Subject: Recall R89573

**Recall R89573: XC90 Inflatable Curtain  
Model Year 2016 XC90**

TJ 30704

<b>Title</b>	Inflatable curtain	<b>Page</b>	1 (7)
<b>Action</b>	Adjustment

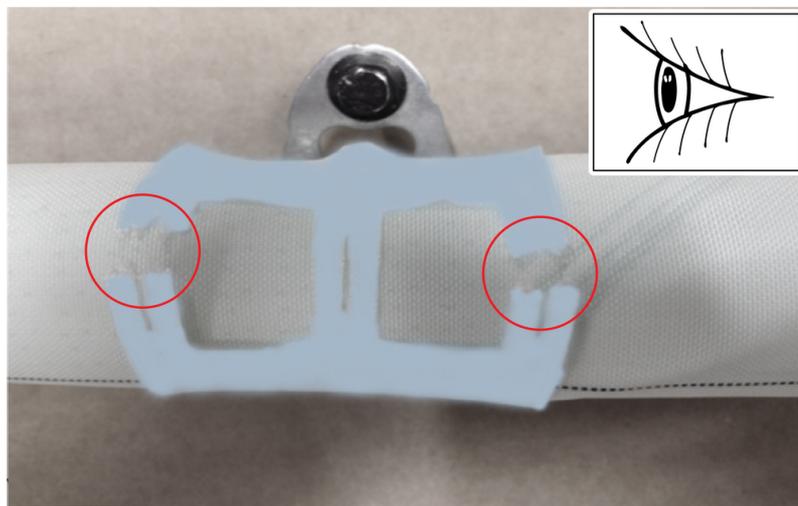
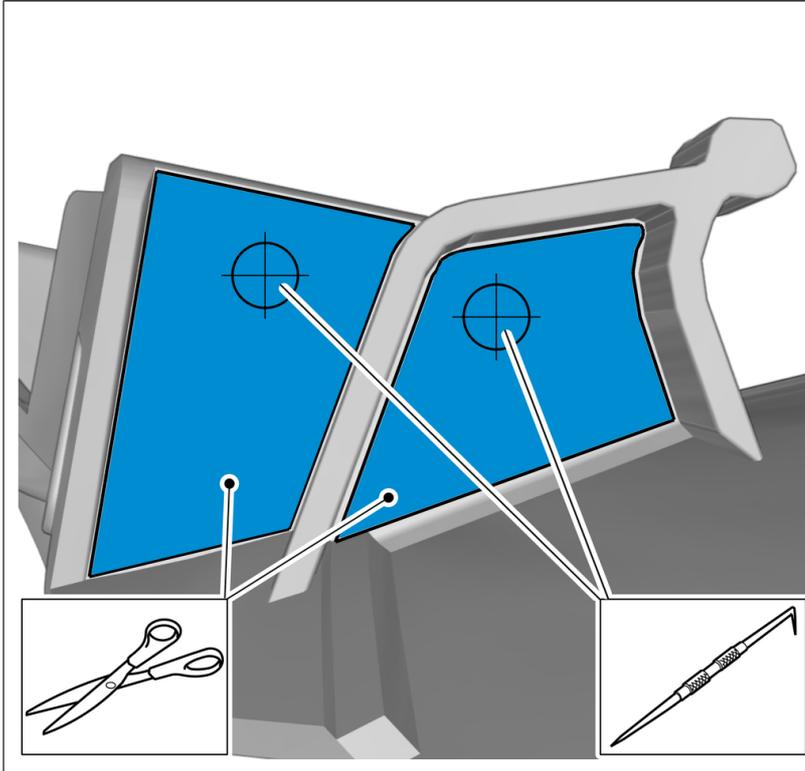
Cut following the dotted lines.  
On both sides.

**Note! Make sure that the template is correctly located.**

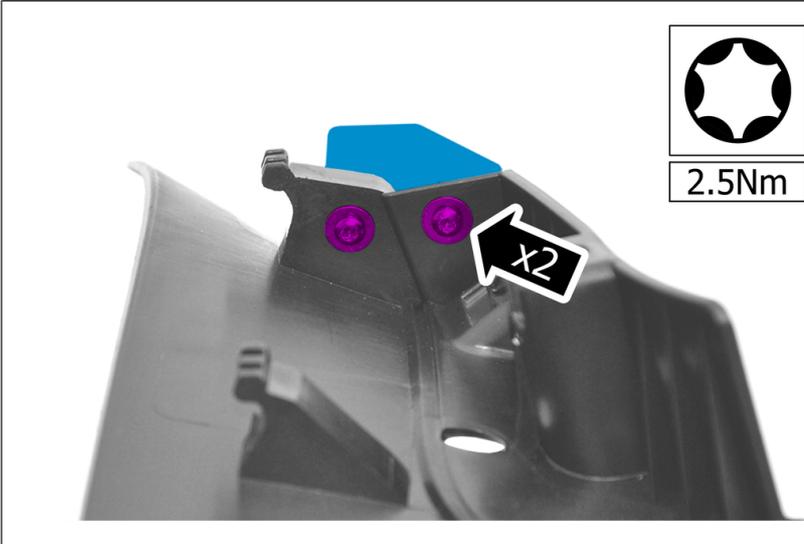
Use a drill with the stated size  
On both sides.

Tighten the bolts.  
On both sides.
